UNC Workgroup Report

UNC 0607S:

Amendment to Gas Quality NTS Entry Specification at the St Fergus NSMP System Entry Point

Figure 3: 'Heat map' for BP scenario 1

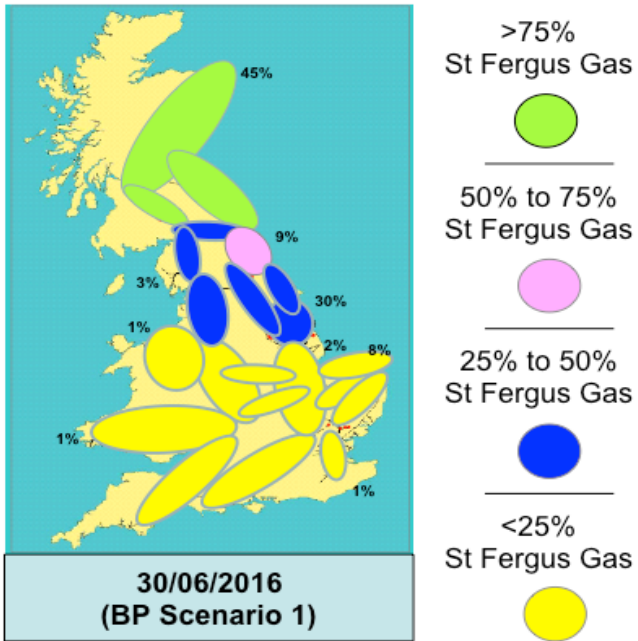
Comment [C1]: To be updated to include the weighted average CO₂ positions and the maximum daily CO₂ levels.

Comment [RH2R1]: Need to Update following 22/5/17 NTS presentation into appendix along with average daily cost from Feb 2017 WG meeting
